STATE OF NEVADA
Department of Conservation & Natural Resources
DIVISION OF ENVIRONMENTAL PROTECTION

Re: **Tronox LLC (TRX)**
NDEP Facility ID #H-000539
Nevada Division of Environmental Protection (NDEP) Response to:
*Revised Excavation Plan for Phase B Soil Remediation of RZ-D, Addendum to the
Removal Action Work Plan, Tronox LLC, Henderson, Nevada*
Dated: August 31, 2010

Attachment A

Figure C-1

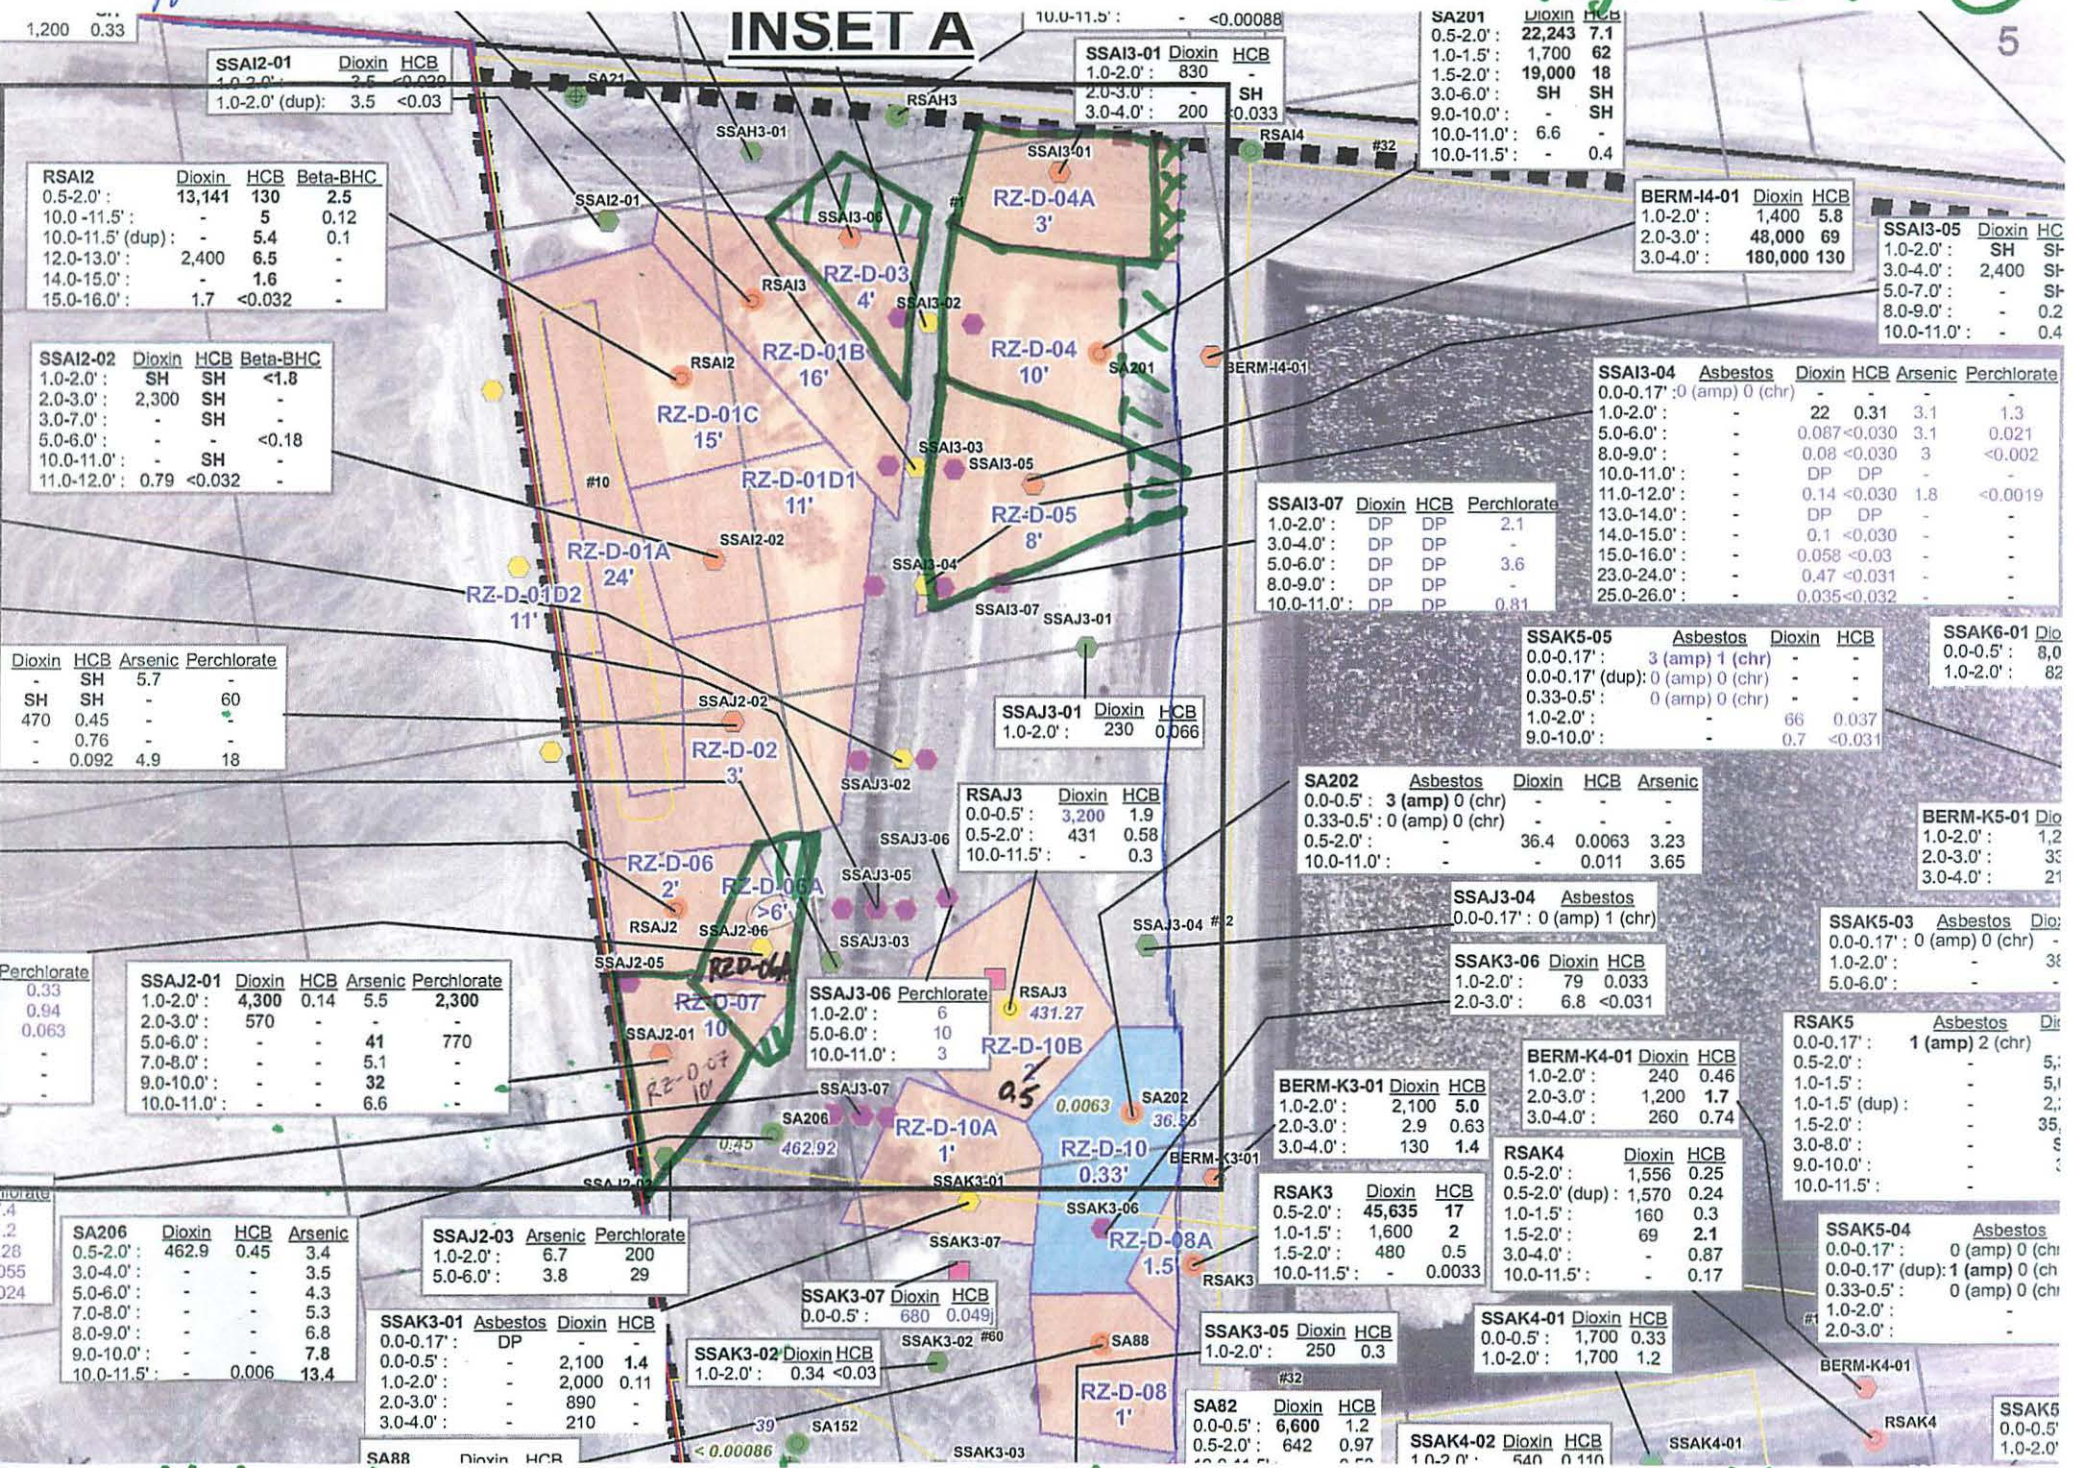
Excavation Area	Contaminated Sampling Location	Adjacent Sampling Locations	Depth fbgs	Exceptions
RZ-D-01A	Hazardous Waste Landfill (HWL)	Limits of the HWL	24	
RZ-D-01B	RSAI3	SSAI2-01 SSAH3-01 RSAI2	16	Western cutline: western property boundary **HWL located within this area
	SSAI3-03-SW-W	SSAI3-03		
RZ-D-01C	RSAI2	SSAI2-01 RSAI3 SSAI2-02	15	Western cutline: western property boundary
RZ-D-01D1	SSAI2-02	SSAJ2-02 RSAI2	11	Eastern cutline: boundary of Trade Effluent Pond berm Western cutline: western property boundary **HWL located within this area
RZ-D-01D2			11	Eastern cutline: HWL boundary Western cutline: western property boundary
RZ-D-02	SSAJ2-02	SSAI2-02 RSAJ2	3	Eastern cutline: boundary of Trade Effluent Pond berm Western cutline: western property boundary
RZ-D-03 (C-1)	SSAI3-06	RSAI3 SSH3-01 RSAH3	4	
	SSAI3-02-SW-W	SSAI3-02		
RZ-D-04 (C-1)	SA201	SSAI3-01 SSAI3-05	10	Eastern cutline: toe of GW-11 pond berm (or approved setback)

SSAI3-02-SW-E	SSAI3-02		
RZ-D-04A (C-1)	SSAI3-01	RSAH3 SA201 RSAI4	3	Northern cutline: Parcel C boundary

Excavation Area	Contaminated Sampling Location	Adjacent Sampling Locations	Depth fbgs	Exceptions
RZ-D-05 (C-1)	SSAI3-05	SA201 SSAJ3-01	8	Eastern cutline: toe of GW-11 pond berm (or approved setback)
	SSAI3-03-SW-E	SSAI3-03		
	SSAI3-04-SW-E	SSAI3-04		
RZ-D-06	RSAJ2	SSAJ2-02 HWL SSAJ2-01 SSAJ2-06	2	Western cutline: western property boundary
RZ-D-06A (C-1)	SSAJ2-06	RSAJ2 SSAJ2-01 SSAJ3-07 SSAJ3-03 SSAJ2-02	≥6	
RZ-D-07 (C-1)	SSAJ2-01	RSAJ2 SA206 SSAJ2-06	10	Western cutline: western property boundary
RZ-D-08	SA88	SSAK3-05 SSAK3-02 SSAK3-06 RSAK3	1	Eastern cutline: toe of GW-11 pond berm
RZ-D-08A	RSAK3	SSAK3-06 SA88	1.5	Eastern cutline: toe of GW-11 pond berm
RZ-D-10	SA202	RSAJ3 RSAJ3-04 SA88 SSAK3-01	0.33	Eastern cutline: toe of GW-11 pond berm
RZ-D-10A	SSAK3-01	SA202 RSAJ3 SA206 SSAK3-07 SSAK3-06	1	
RZ-D-10B	RSAJ3	SSAJ3-05 SSAJ3-03 SSAJ3-07 SSAK3-01 SA202 SSAJ3-04	0.5

Figure C-4

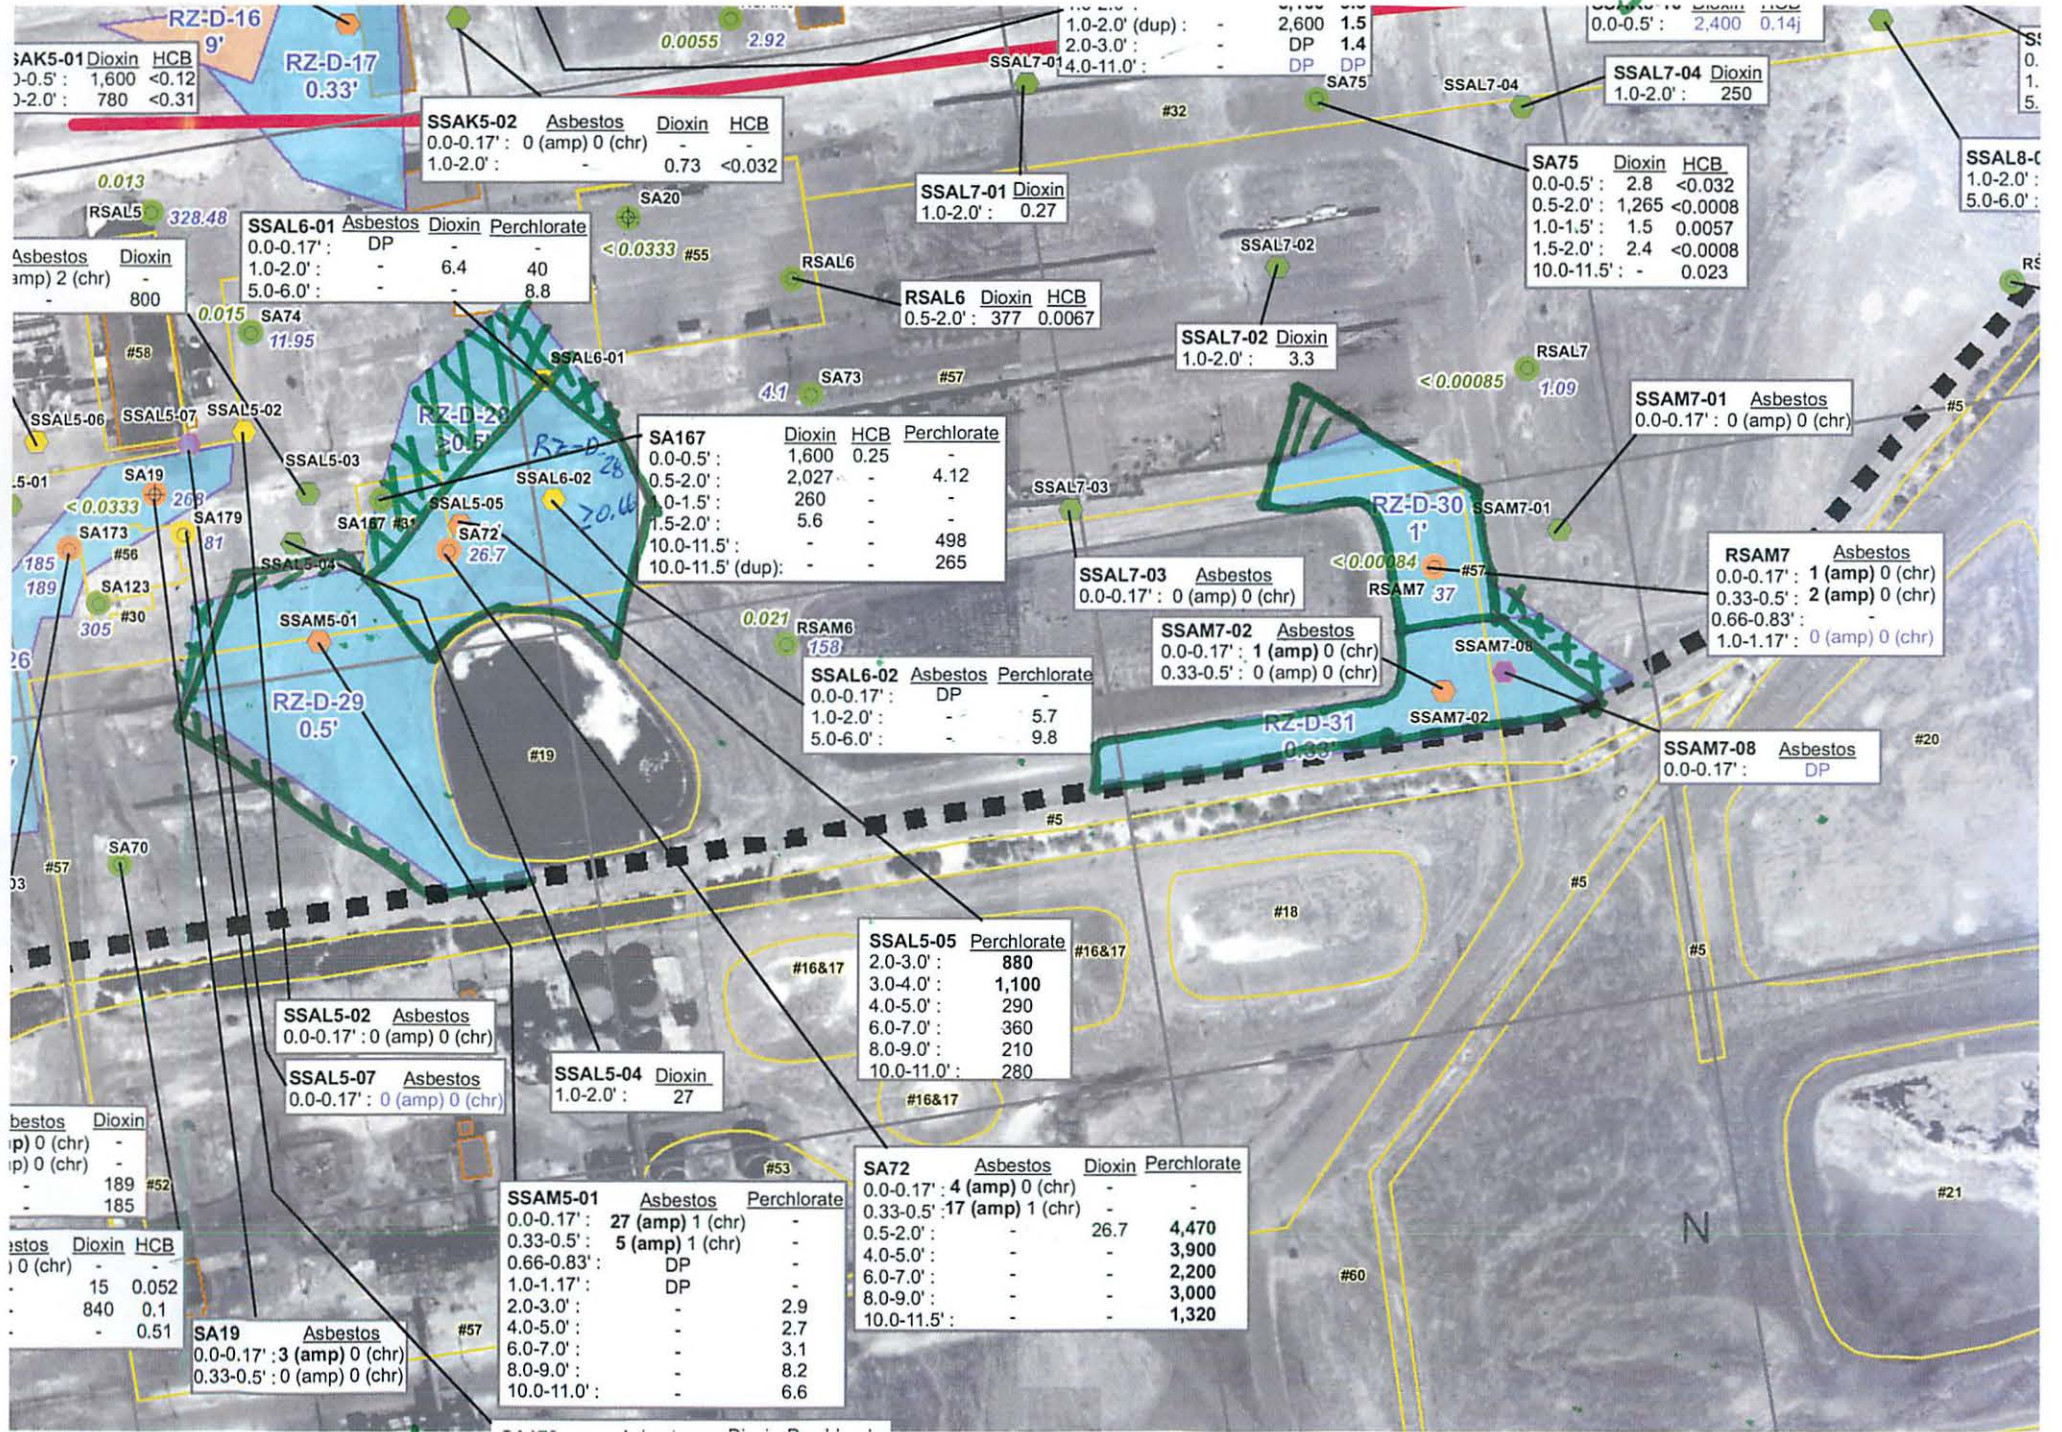
- e. RZ-D-28 / RZ-D-28A, TRX states that they have “elected to keep RZ-D-28 as one area”. Additionally, TRX states that this one area will be excavated to 10 fbgs. However, based on discussions on September 27, 2010 between NDEP and TRX and the September 27, 2010 Errata, NDEP understands that TRX will continue to investigate alternate remediation options for the perchlorate contaminated soils; therefore, TRX will excavate the asbestos contaminated soil and will recommend an alternative remedial method for the perchlorate-only contaminated soils. Please see Attachment B table and Figure C-4 for additional information.

RZ-D-29 (C-4)	SSAM5-01	SSAL5-03 SA167 SA72 SA70 SA123 SA179	≥0.66	Eastern cutline: toe of AP-5 pond berm

Excavation Area Name	Contaminated Sampling Location	Adjacent Sampling Locations	Depth fbg	Exceptions
RZ-D-30 (C-4)	RSAM7	SSAM7-02 SSAL7-03 RSAL7 SSAM7-01	1	Southern cutline: RZ-E cutline NDEP currently does not approve exclusion of the roadway from excavation.
RZ-D-31 (C-4)	SSAM7-02	RSAM6 RSAM7 SSAM7-01	0.33	Southern cutline: RZ-E cutline NDEP currently does not approve exclusion of the roadway from excavation.
